SERVICE BULLETIN No. 92

SEC. VIII, DIV. A
SERVICE BULLETIN
ISSUED APRIL, 1961

SUBJECT: Change in Carburetor Inlet Seats

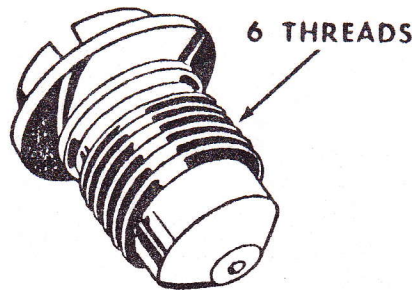
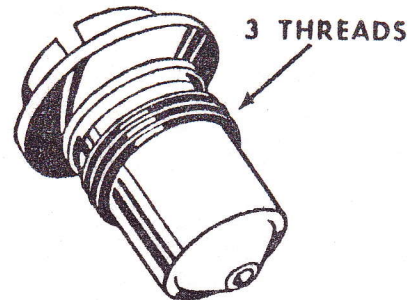
Clinton Carburetor Inlet Seats have been changed from "6 thread" inlet seats to "3 thread" inlet seats. Carburetor bodies were also changed. The present seats will not fit in the newest carburetor bodies. The "6 thread" and "3 thread" seats are illustrated below.

Your present stock of parts can be used for repairing most carburetors. An "R" has been added to the part number to indicate the new or revised inlet seat. For example, 14211 would indicate the standard "6 thread" seat. Number 14211-R would indicate the new seat "3 thread" which will be needed in many cases this season to service the present carburetor. The "3 thread" seat assembly must be used on carburetors which have only 3 tapped threads. The new parts will eventually deplete out the present needle and seat assembly. Part numbers involved are as follows:

NOTE: The new P-14559-A-R seat is interchangeable with the old P-14559-A and 14391-A seats.
